PATTERSON-RIVERSIDE BRIDGE

PIERS

Scale: AS SHOWN Size: 22" x 35" Sheet 41 of 55 Sheets

PATTERSON-RIVERSIDE BRIDGE
PIER #1
Scale: AS SHOWN Size: 22" x 35" Sheet 41A of 55 Sheets
DEPARTMENT OF SERVICE & BUILDINGS
DIVISION OF ENGINEERING
DAYTON, OHIO.
Design 9-25-53 By J.A.G. Approved
Traced 9-25-53 By E.H. [Signature]
Checked 9-30-53 By G.F.S., L.S. [Signature] Engineer
Loose Leaf [Signature] Drawing No. 2A-9327

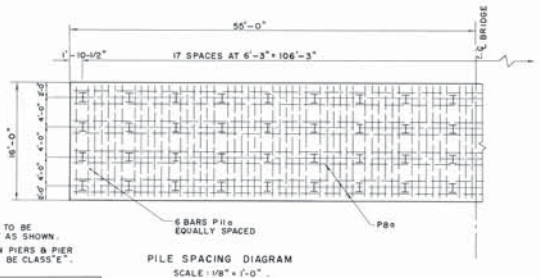
REVISION 1: FOR PILING AND FOOTER UNDER PIER 1, SEE SHEET NO. 41-A.

REVISIONS		
Date	Character	By
PIER NO. 1		
10-1-55	PILING & FOOTER L.S.
